**AGENDA
FARRAGUT MUNICIPAL PLANNING COMMISSION**

**March 21, 2019
7:00 p.m. Farragut Town Hall**

FRONT ELEVATION

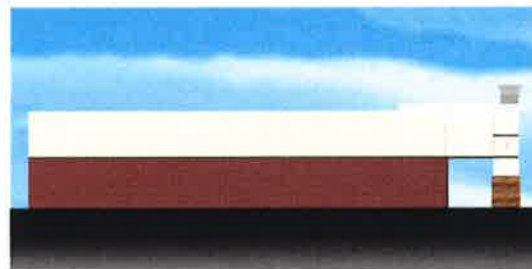
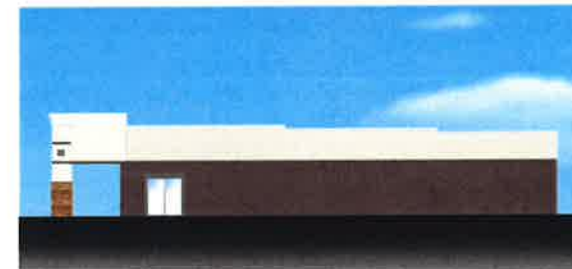
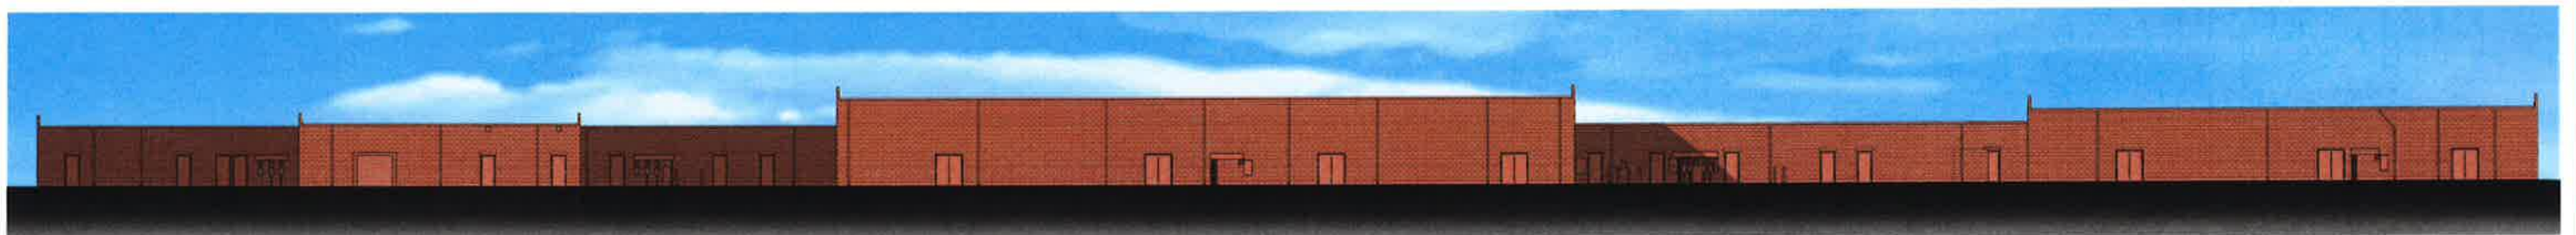
RECOMMENDATION: During the discussion with the applicant at the staff/developer meeting on March 5, staff asked the applicant to account for the HVAC screening that would be required for new units to be mounted on the roof. Staff also asked that the applicant incorporate some measures to break up to the "blank wall" appearance of the west, north, and east elevations. The applicant acknowledged that they would provide for the required HVAC unit screening as stipulated in the Zoning Ordinance. And, since the west, north, and east elevations are existing, the applicant is proposing to address the blank wall issue with painting patterns. The applicant will have material and color samples at the meeting and will review the painting patterns on the west, north, and east elevations. Staff recommends approval with the understanding that the HVAC units must be screened as required in the Farragut Zoning Ordinance.

SITE LAYOUT PLAN
Scale: 1" = 20'-0"

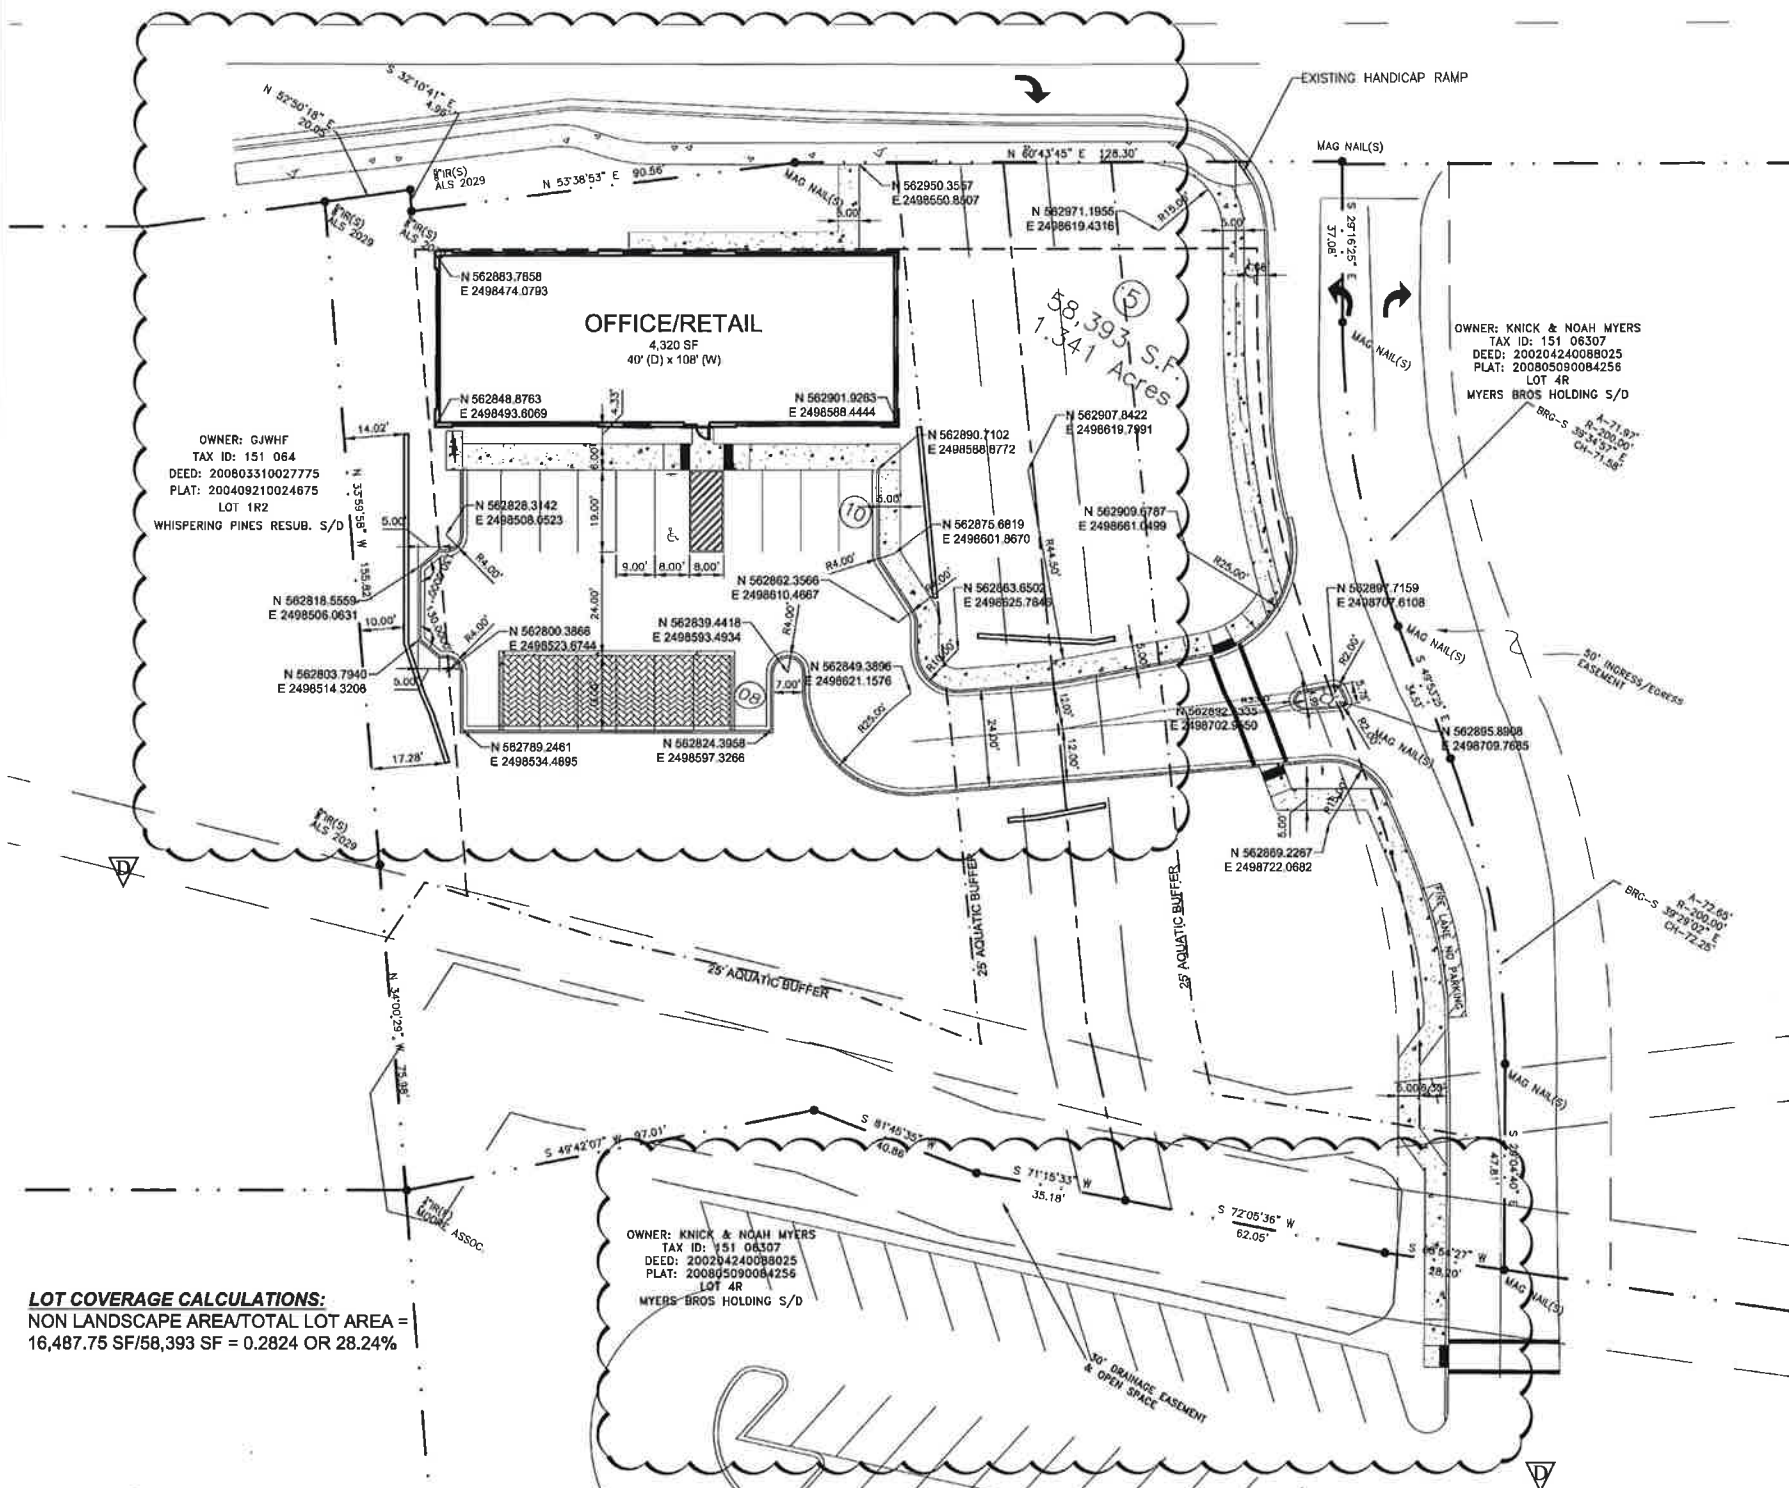
1. Please add a setback dimension between the retaining wall at the western end of the parking lot and the property line.
2. A minimum 5-foot wide terminal island is required at the end of all parking isles. The proposed retaining walls appear to limit terminal island width in some areas, please adjust the plan. Perhaps one parking space could be removed (since you are one over) and then the space could be freed up for the correct terminal island minimum widths.

3. The parking ratio is calculated based on the requirements for general retail and office uses. Please note this on the plan.
4. The response/comment letter submitted with the plans indicates that the proposed sidewalk widths have been increased to 5 feet. The plan notes do not reflect this, please correct.

1. We have added the requested dimensions to drawing C3.1.
2. We have adjusted the parking field to make sure all of the terminal islands are a minimum of 5', see drawing C3.1,

3. We have added the verbiage to the parking ratio calculations to state they are based on "General Retail and Office use", see drawing C3.0.
4. We have added the additional dimensions to the sidewalks to define all are to be a minimum of 5' wide, see drawing C3.1.
